**INFORMAL REFERRAL COMMENTS – DA 090/M021/20  
70 GREENHILL ROAD WAYVILLE**

*Construction of a multi-storey, mixed use building comprising residential and commercial uses together with carparking and site works.*

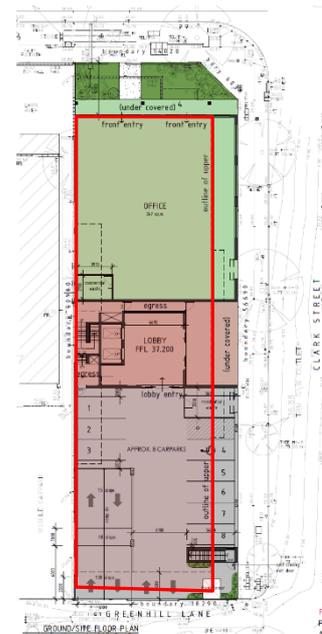
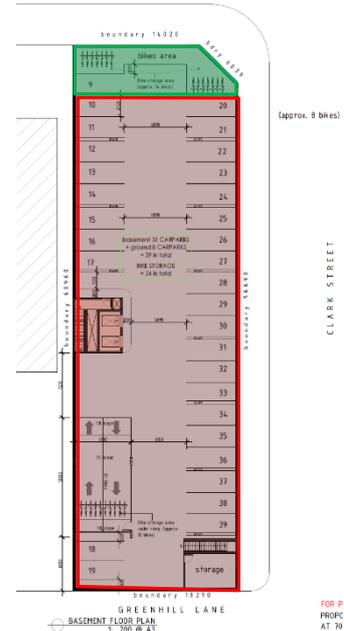
- The Building Interface Envelope (30 degrees at 3m) is applicable from the zone boundary to limit overbearing building mass, overshadowing and provide a proper and orderly demarcation for diverse development. The existence of an atypical non-residential use to the rear does not change the long-term zoning and intended future development nature nor the existence of low-density residential dwellings in proximity to the east and west;
- At the ground level 6.0 metre Greenhill Road setback provided but space encroached in effect by full height solid columns and projecting balconies;
- Rear lane setback of 6.5 metres from opposite side, and therefore 0.4 metres from boundary, provided for;

- At the ground level Clark Street 0.0m setback does not address required 3.0m side street setback, providing no relief to street from long, harsh and plain building façade and excessive building foot print of 86% compared to conforming one of 75%. Acknowledge setback provided above ground level, for residential amenity and building articulation;

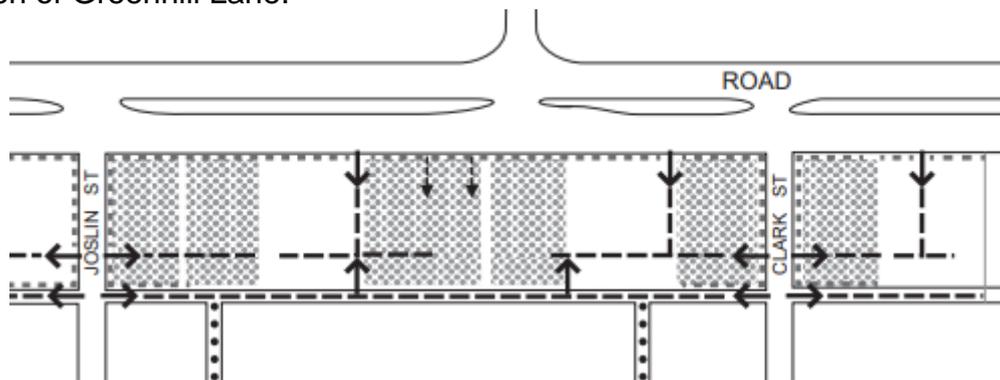
Vehicle access is entirely from Greenhill Lane (6.1 metres wide) and via two two-way crossovers (comprising 12.2 of 18.1 metres frontage). This replaces the existing single two-way crossover to Greenhill Lane.

Greenhill Lane is a two-way lane currently providing access to 10 car parks on the northern side, only one of which has a dual access from Greenhill Road. It also provides rear access to residential properties on the southern side. Traffic counts undertaken in 2018 indicate that Greenhill Lane carries approximately 450 vehicles per day. However, as this data is generally collected approximately half way between Joslin Street and Clark Street, it does not capture traffic entering and exiting from the same street (for example, entering from Clark Street and accessing a car park to properties 64-70 Greenhill Road, and exiting to Clark Street). This suggests that the traffic volume is likely significantly higher.
